Project No. R2014-02996 – Conditional Use Permit No. 201400142
RPC Meeting: September 16, 2015 - Agenda Item: 7

The above-mentioned item is a request to authorize the establishment and operation of a Taco Bell restaurant, including drive-through facilities, within the C-2-DP (Neighborhood Business-Development Program) Zone, the Soledad Zoned District and the Acton Community Standards District.

**TACO BELL ACTON-3771 SIERRA HIGHWAY
CONDITIONAL USE PERMIT (CUP) NO. 201400142
PROJECT NO. R2014-02996
ASSESSOR'S MAP BOOK NO. 3217, PAGE 21, PARCEL NO. 11
UNINCORPORATED COUNTY COMMUNITY OF ACTON**

Subject: Taco Bell/First Street development proposal in Acton

Taco Bell - Monument Sign - 32sf

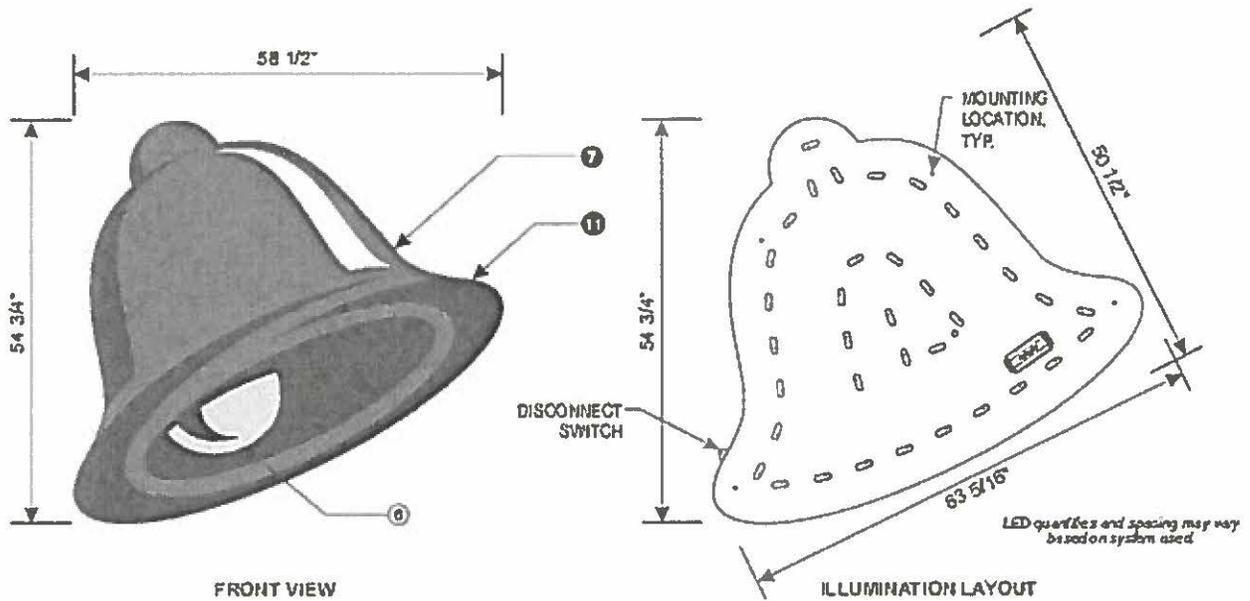
1) According to the Signage Plan submitted to the community in July, 2015 (and included at the end of this attachment), the project includes a 9 foot monument sign, which violates the following provision of the Acton CSD and requires a variance:

2) According to the Signage Plan, the monument sign is internally lit with multiple led lights and/or "Halo" illumination which violates the following provision of the Acton CSD and requires a variance:

Taco Bell - Swinging Bell - Formed Face

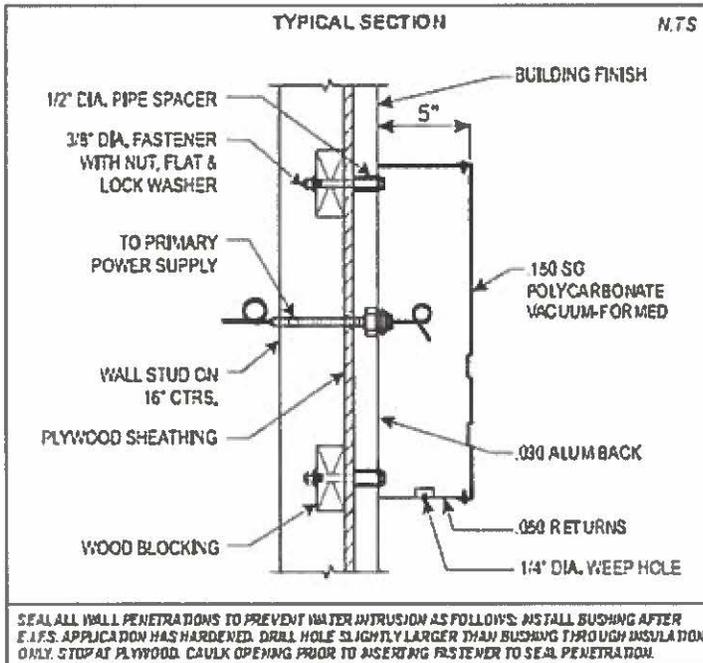
3) According to the Signage Plan, all wall signs are internally lit with multiple led lights and/or "Halo" illumination which violates the following provision of the Acton CSD and requires a variance:

4) According to the Signage Plan, all signs are in garish neon pink and bright purple colors with a non-western style which violates the following provisions of the Acton CSD and requires a variance:

WEST ELEVATION (FACING CROWN VALLEY RD)
SCALE 1/4" = 1'-0"

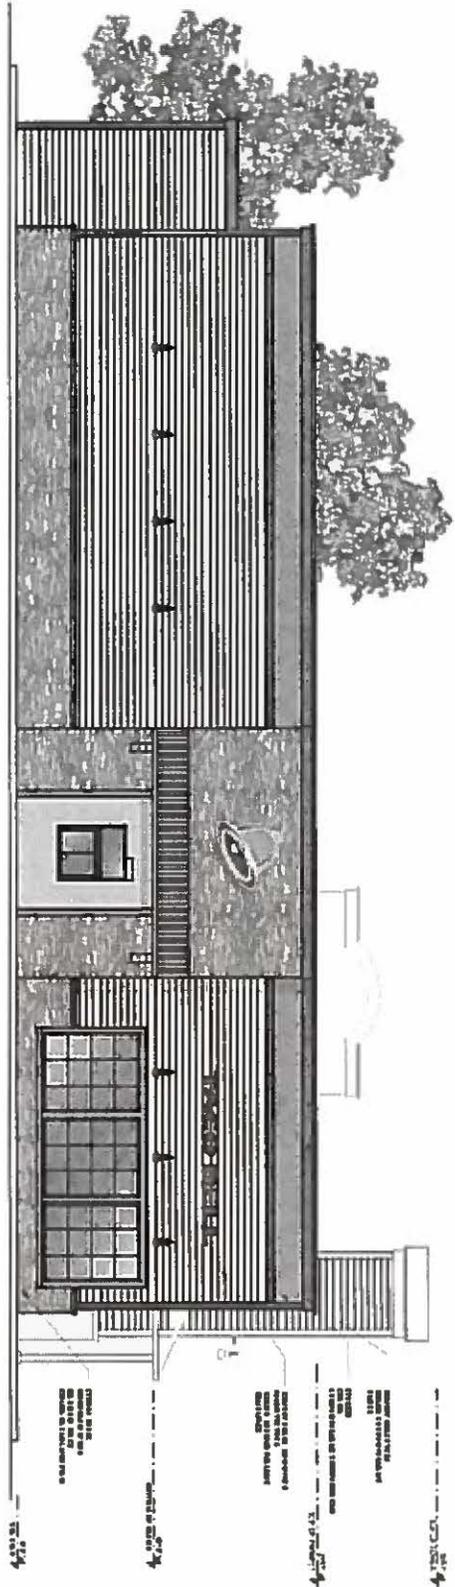
5) According to the Plan and Elevation Drawings submitted to the community in July, 2015 (provided at the end of this attachment), the east façade includes a brightly colored, internally lit wall sign that advertises the business, will be highly visible from the freeway, and is intended to pull customers from the freeway. It therefore meets the definition of a “freeway oriented sign”. The east façade is not a frontage face and though there is an entrance on this side of the building, the sign is not intended to identify the entrance, rather it is intended to advertise to commuters on the freeway. Therefore, the placement of any such sign on the east façade does not comply with either the Acton CSD or zoning code section 22.52.880, and requires a variance.

6) According to the Site Plan submitted to the community in July, 2015, the south façade is 27 feet 4 inches long; therefore 41 sq. ft. of sign area is allowed according to the following provision of the Acton CSD. It is not clear from the Signage Plan provided to the community in July 2015 that the signage proposed for the south façade meets these CSD provisions; if it does not, then a variance is required to comply with the following requirement:
